FIELD OBSERVATION REPORT

Central Hardin High School, Cecilia, KY

2019111 - CA8

Report No: 44

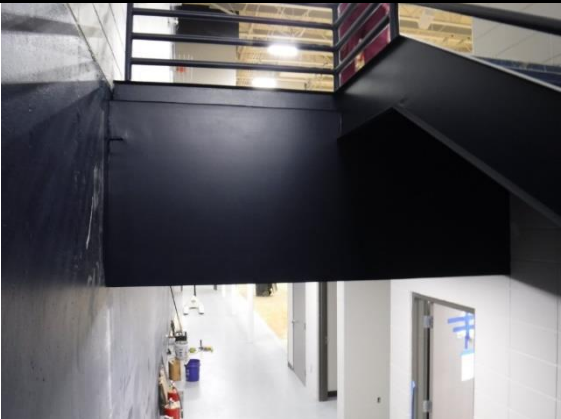
Item No.	Location	Description/Correction	Image	Action
4	Area A Stone at Gym Entry.	The steel downspout boot was positioned to miss the light fixture which put is outside the edge of the canopy. The downspout will have to jog at the top to connect to the canopy.		Make offset in downspout.
5	Area A Gym Lobby.	The wood flooring was installed over the concrete base for the bench. The glass railing was mostly complete. The terrazzo was not installed due to high moisture in the slab.		Monitor slab moisture levels and report when it is acceptable.
6	Area A Gym Lobby.	Most of the finish materials were in place.		Protect finishes from construction activities.
